ADDENDUM - BAKERSFIELD CITY SCHOOL DISTRICT  
ROOSEVELT SCHOOL MODERNIZATION

ADDENDUM NO: ONE (1)

PROJECT: BAKERSFIELD CITY SCHOOL DISTRICT  
ROOSEVELT SCHOOL MODERNIZATION

ARCHITECT'S  
PROJECT NO: 88-142

ADD.  
 19

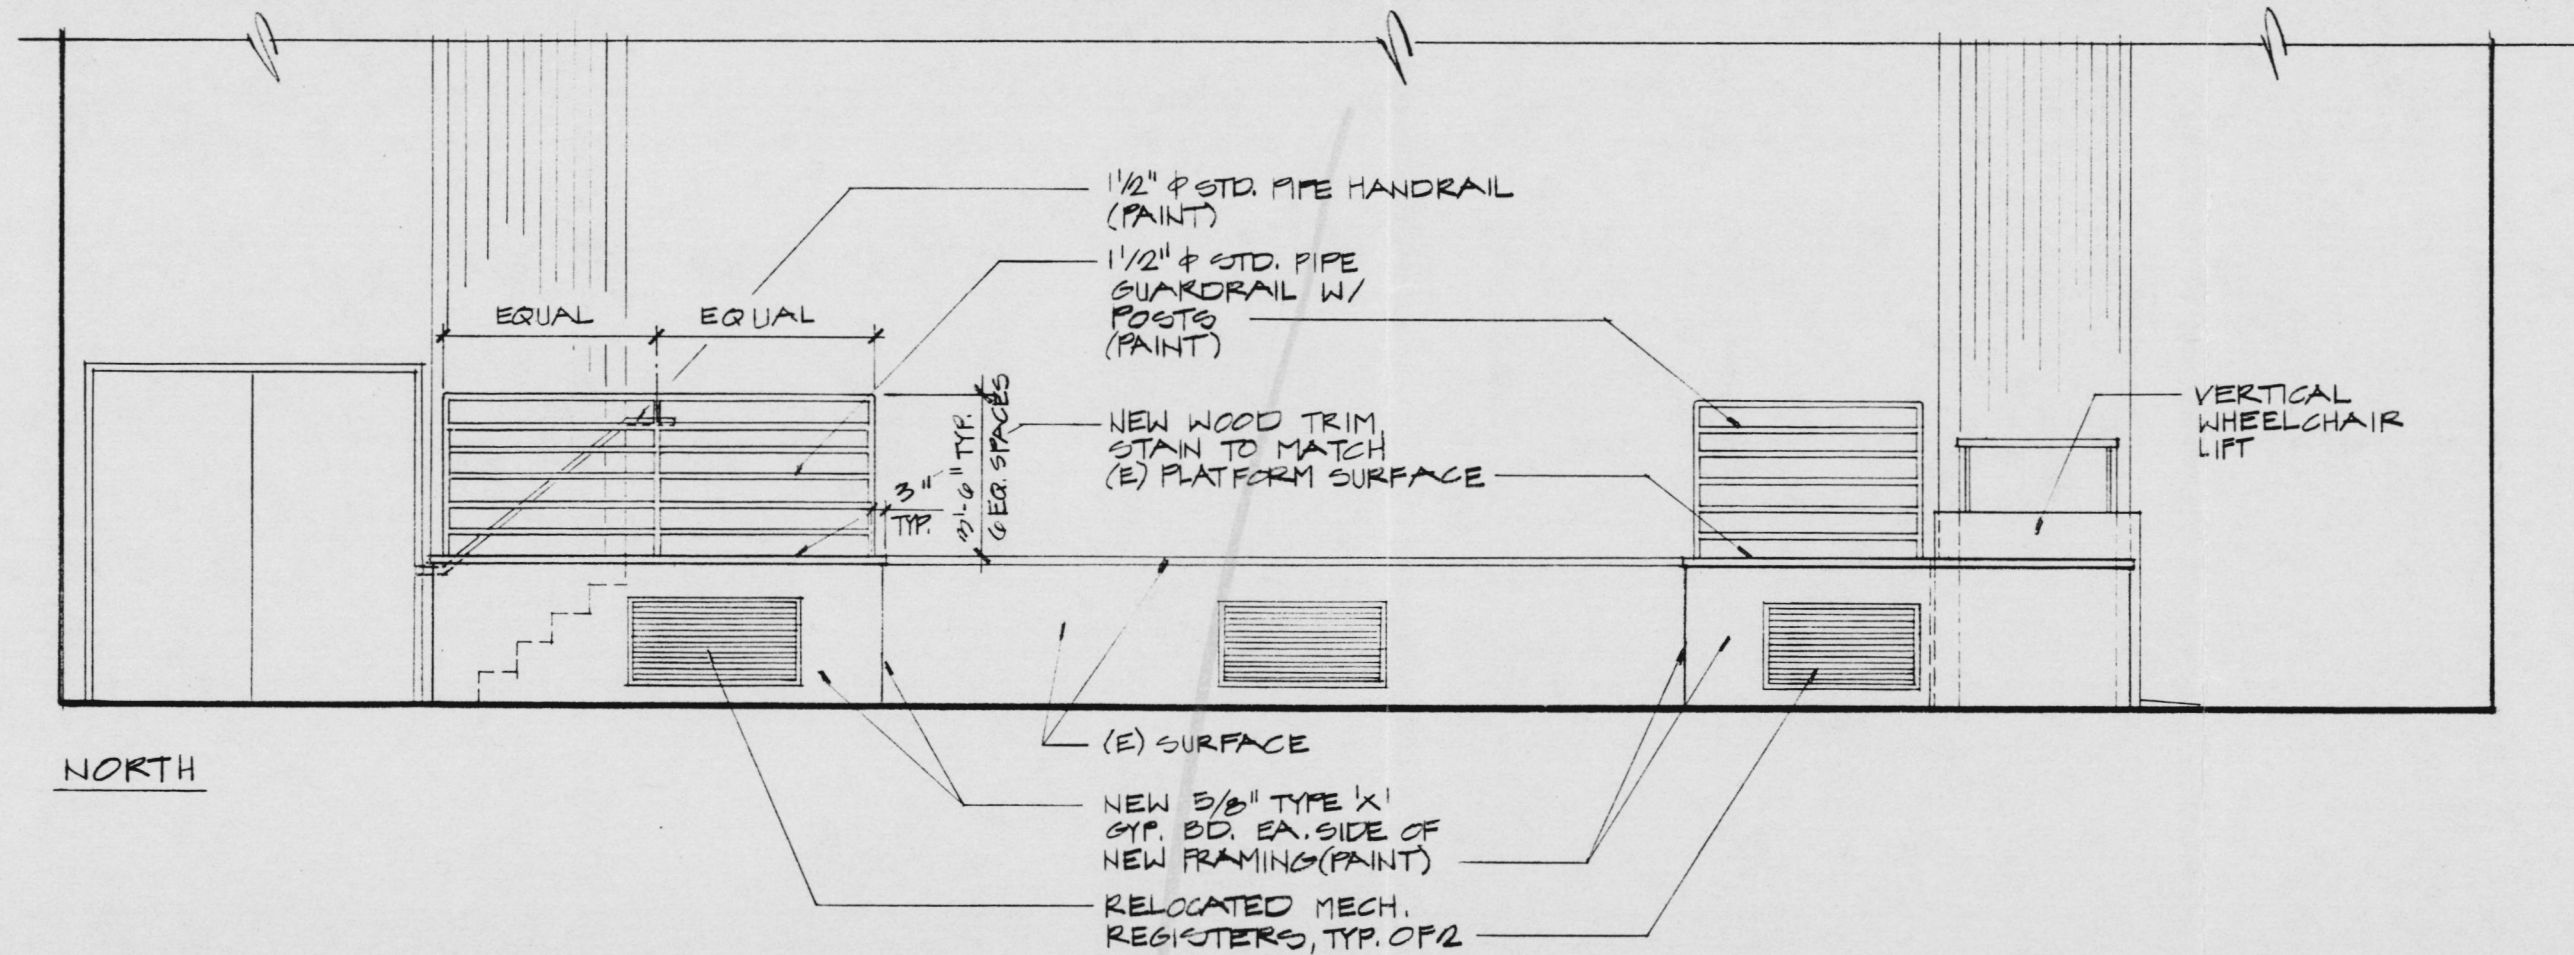
Item (31) Refer to Sheet A6.00, Keynote 603:

Revise installation of the handicap lift per the attached sketches ADD1-9, ADD1-9A, ADD1-9B, ADD1-10, ADD1-11, ADD1-12, and ADD1-13.

Note: The flooring material for the "stage" extension shall match as closely as possible the existing Douglas Fir flooring.

ADD  
 1-14

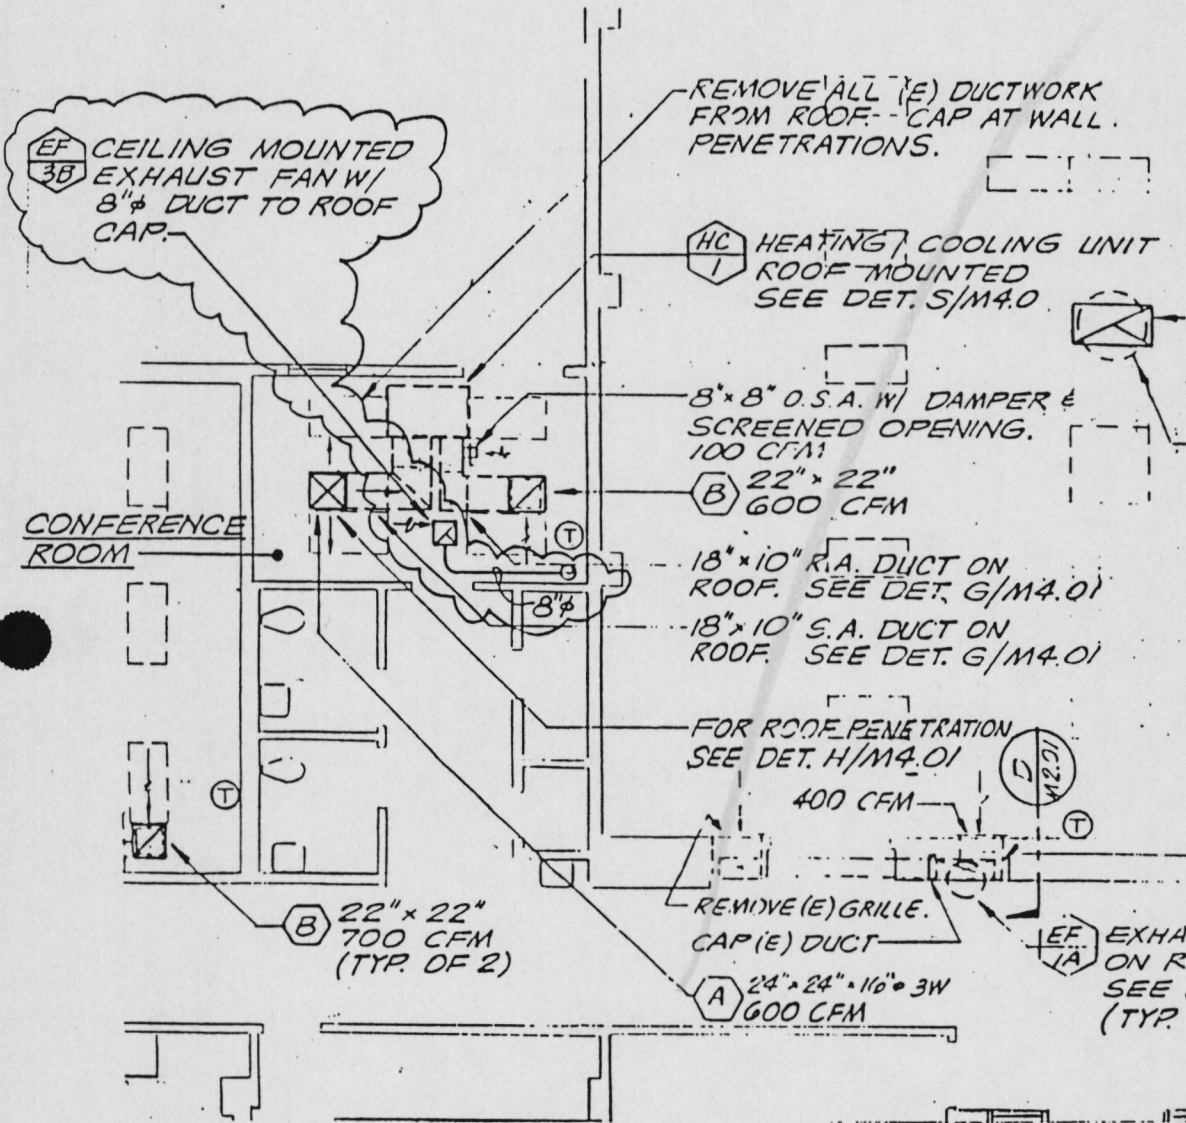
- Item (36) Refer to Sheet M2.00, Chiller Ice Storage Yard Plan:
- Install a brine makeup system as shown on attached sketch ADD1-14. Mount the brine feed tank adjacent to the Amtrol AX60V expansion tank. Verify the exact location in the field with the Architect. Provide a concrete housekeeping pad as shown and per Detail ADD1-20 sim.

- Item (13) Refer to Specification Section 15650, Paragraph 3-09,D,2,e(7) - Ethylene Glycol Safety:
- Delete this paragraph and replace it with the following: Brine Feed System: When the brine system pressure drops to 11 psi at the expansion tank, a relay shall energize the brine feed pump. This pump shall pump brine from the tank into the system. When the system pressure reaches 13 psi, the feed pump shall shut off.

- A float switch mounted in the brine make-up tank shall remain closed as long as the tank is approximately 75% or more full. When this float switch is closed, the chiller shall be enabled to run. When the brine in the tank drops, the switch in the float shall open, this shall prevent the chiller from running.

- The float switch shall be a Paco Pump Polypropylene bulb Roto-Float. A mercury switch in the bulb shall close when the bulb floats, and open when the float hangs. A PVC Jacket cable shall attach to a NEMA 4 junction box mounted on the lid of the tank.

ADD  
 1-15

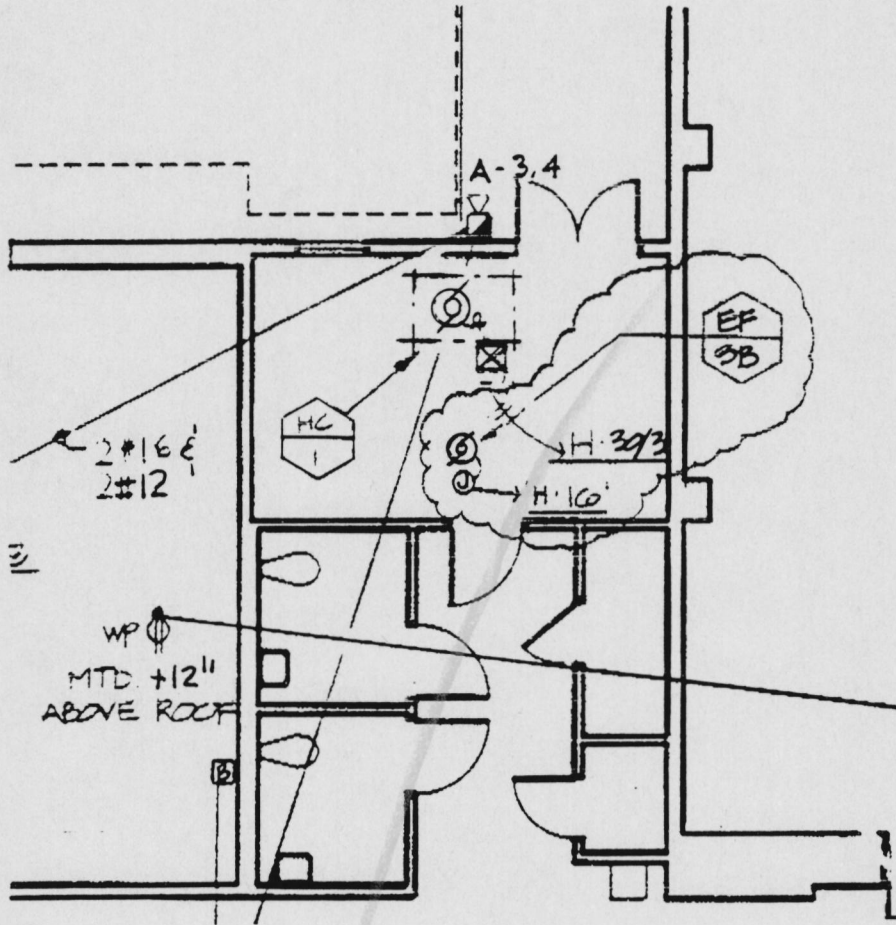
- Item (39) Refer to Sheet M2.01, Building 100 Air Conditioning Plan:
- Install an exhaust fan in the Conference Room 122 per attached sketch ADD1-15. Electrically connect the fan per attached sketch ADD1-16. The roof cap shall be a Penn Model SL20.

ADD  
 1-17

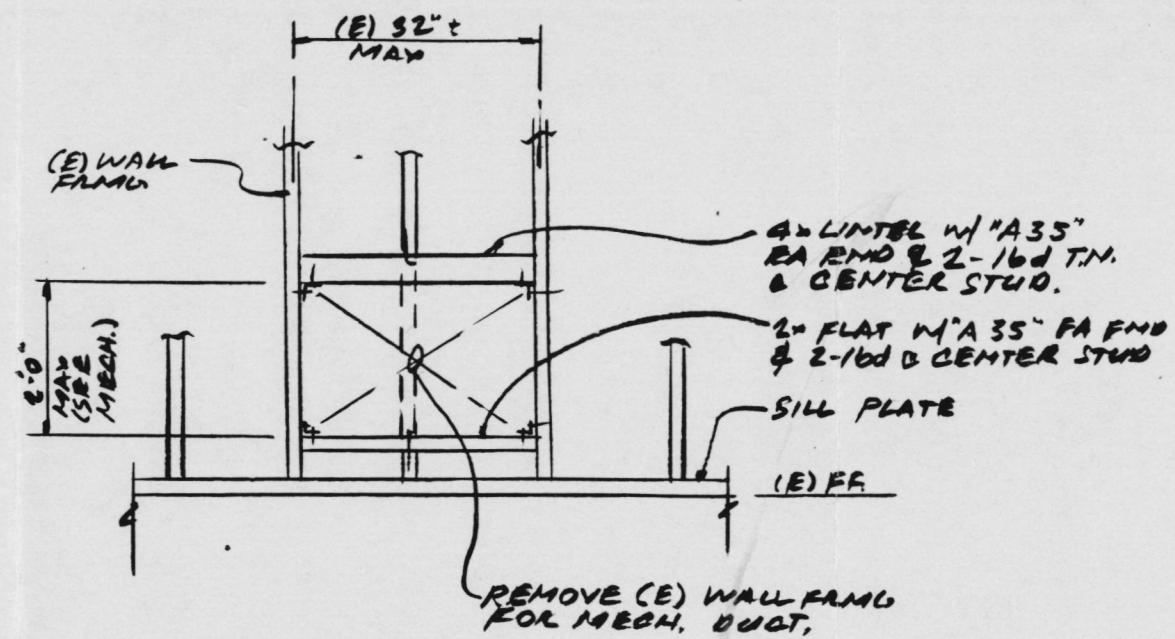
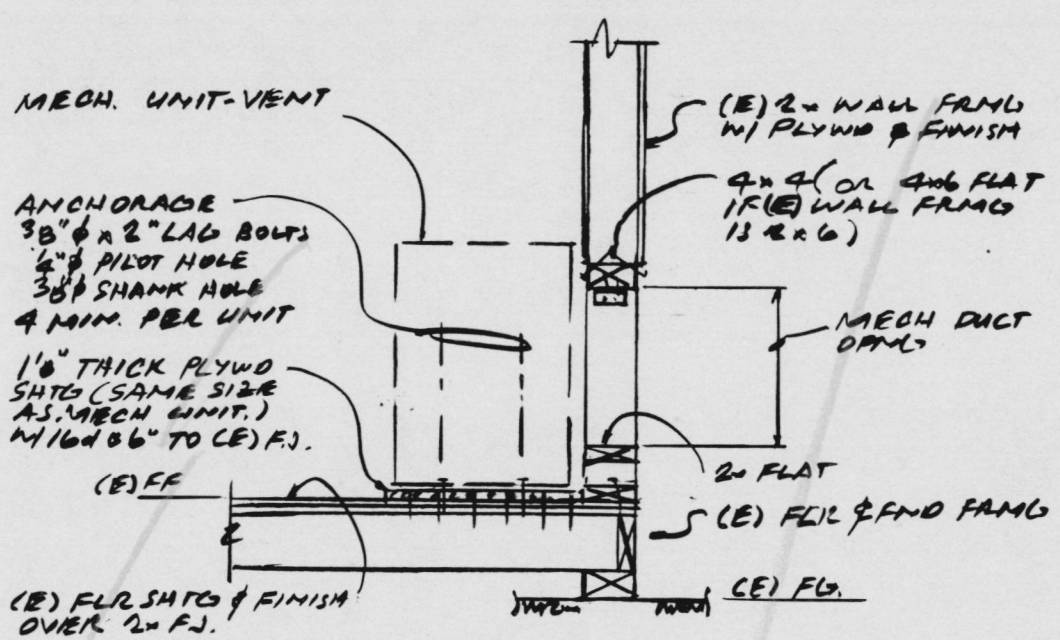
- Item (41) Refer to Sheet M2.02, Building 300:  
Refer to attached sketch ADD1-17 for structural work associated with the new O.S.A. louver. Patch adjacent wall to match existing as required.

JOB NO. 88-142	ADD
DATE 1-8-91	1-18

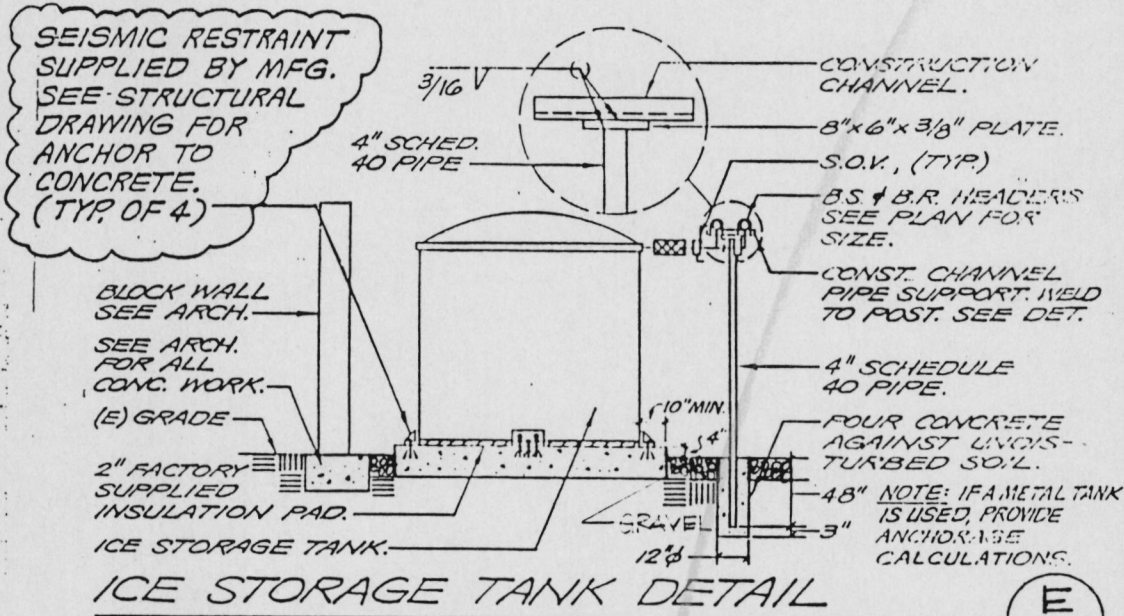
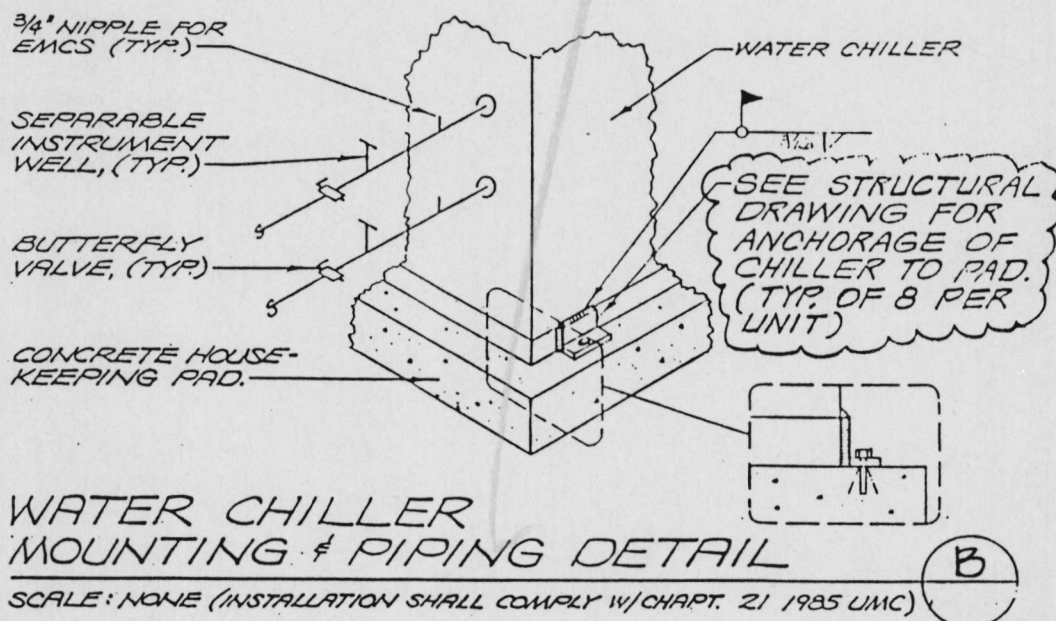
- Item (42) Refer to Sheet M2.02, Building 600:  
Refer to attached sketch ADD1-18 for structural work associates with the new O.S.A. louver. Patch adjacent wall to match existing as required.

ADD  
1-19

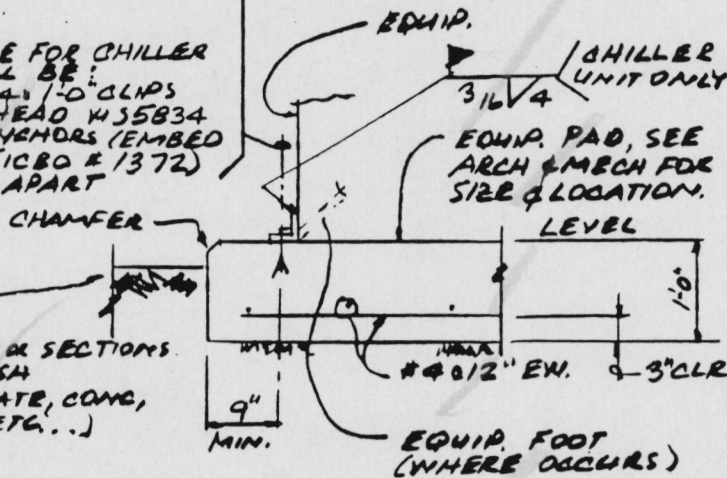
- Item (44) Refer to Sheet M4.00, Details "B" and "E":  
Revise Details per attached sketches ADD1-19, ADD1-20, and ADD1-21.
- Item (45) Refer to Mechanical and Plumbing Drawings:  
Clarification: Note the finish "floor" surface in the Electrical Room S01 and Chiller Room S02 is exposed gravel (refer to structural drawings) not concrete as shown in the mechanical and electrical details. The "minor" housekeeping pads shown shall be constructed per attached sketch ADD1-20 sim. The pads shall be a minimum of 9" wider than the equipment on all sides.

ANCHORAGE FOR CHILLER  
 UNIT SHALL BE:  
 8-L3x3x1/2 CLIPS  
 W/2-REDHEAD W55834  
 WEDGE ANCHORS (EMBED  
 25") EA (ICBO # 1372)  
 SPACE 8" APART

ADD  
1-22

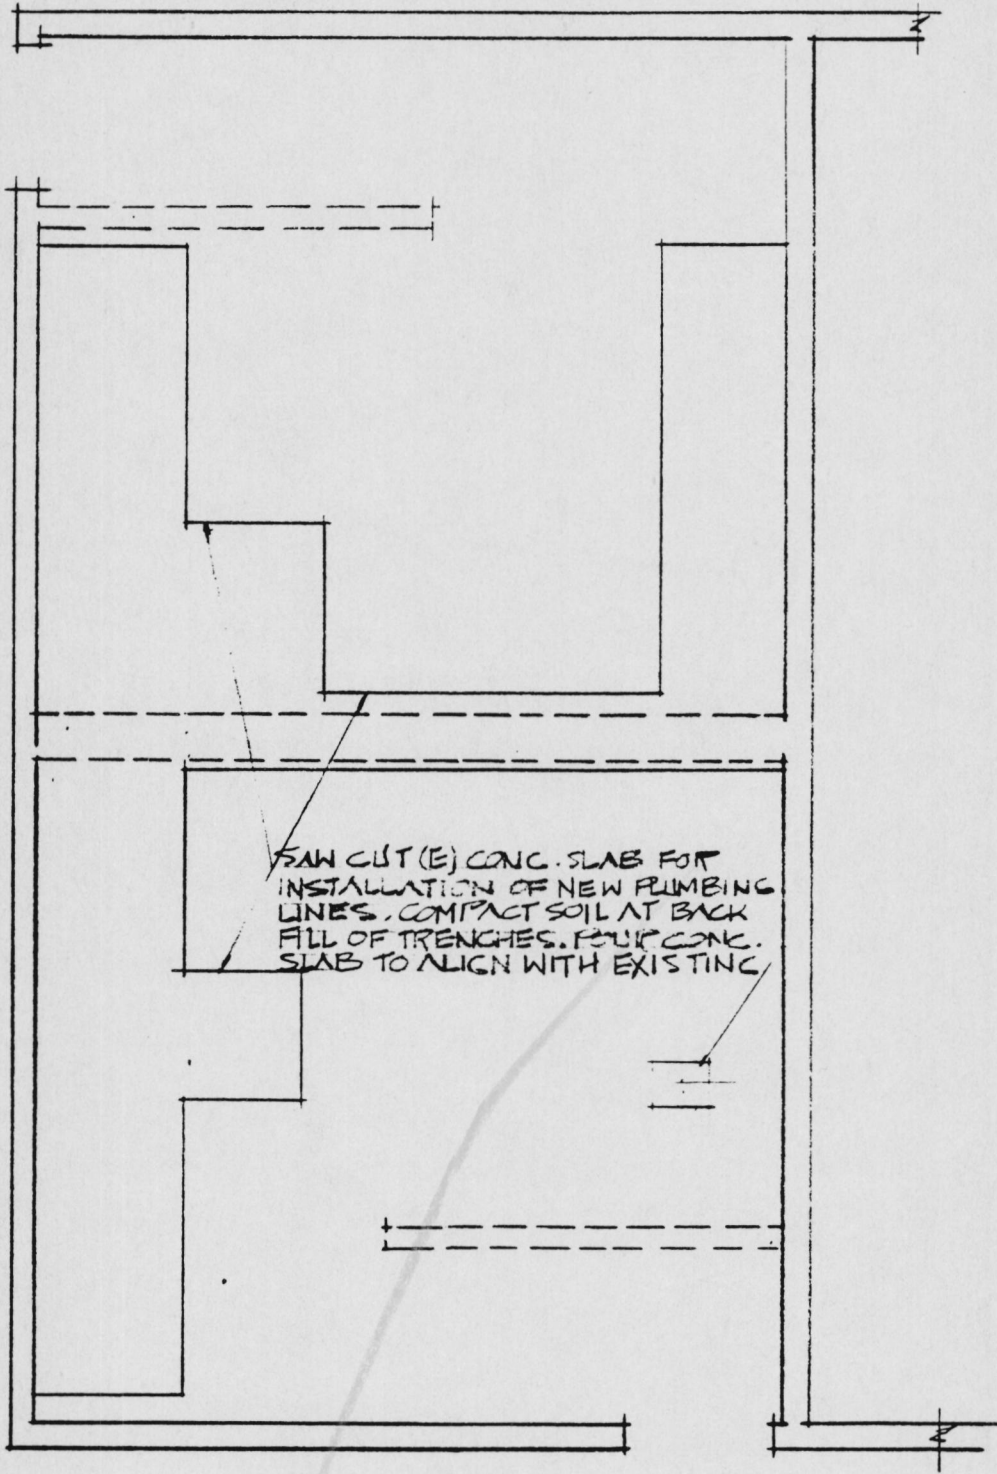
Item (56) Refer to attached sketch ADD1-22:

Add weatherproof receptacles outside of buildings 100, 200, 400 and 500 as shown.
